Service Letter No. 485

Scott Aviation Corporation Modification Instructions I-298 for Mask Assembly - Constant Flow (Semi-Disposable) Scott Part Number 28302

SCOTT AVIATION CORPORATION

MODIFICATION INSTRUCTIONS FOR MASK ASSEMBLY—CONSTANT FLOW

FIGURE 1

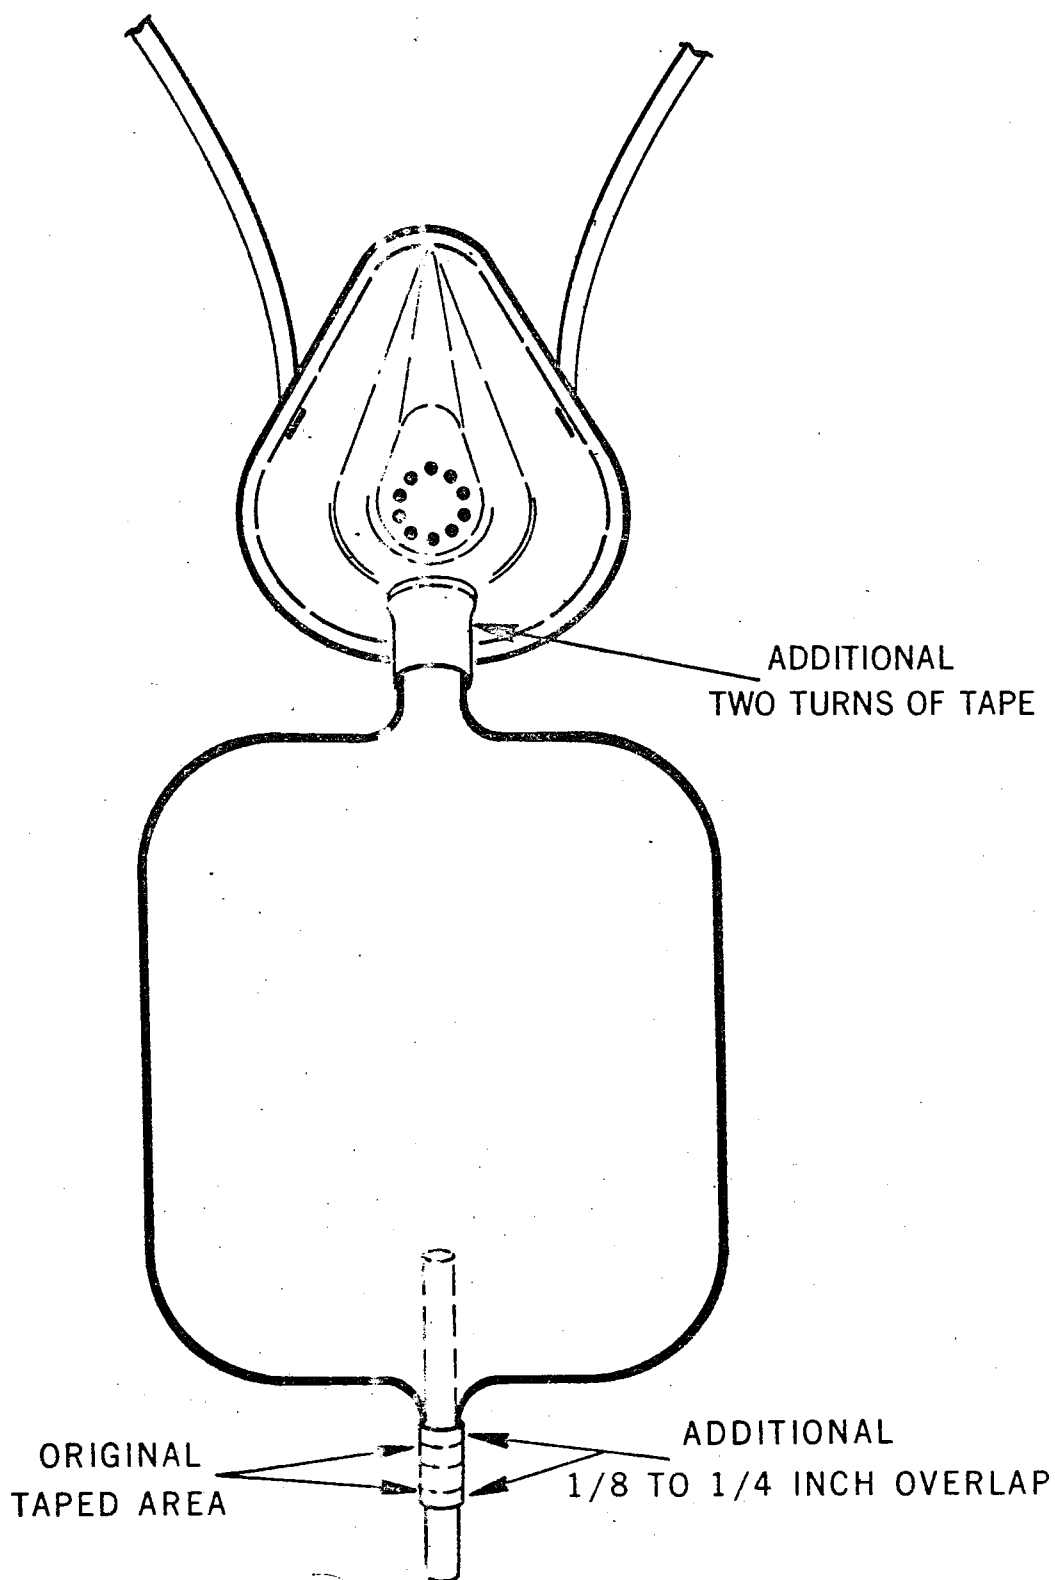
To ensure that the rebreather bag will not separate from either the bag tube or face mask during usage, due to inadequate adhesion of original tape used.

- A. Visually inspect condition of existing tape. If torn or wrinkled, remove tape (see figure 1).
- B. Reposition bag tube (if necessary) so that approximately 1/3 of bag tube protrudes out of rebreather bag.
- C. Apply three to four complete turns of tape (equally spaced over connection), and ensure good contact by tightly stretching tape during application.

The over-tape or new tape must contact the rebreather bag and bag tube, and extend at least 1/8 to 1/4 inch beyond the edges of the original tape.

- D. Apply two additional complete turns of tape (mask to rebreather connection), and ensure good contact by tightly stretching tape during application.
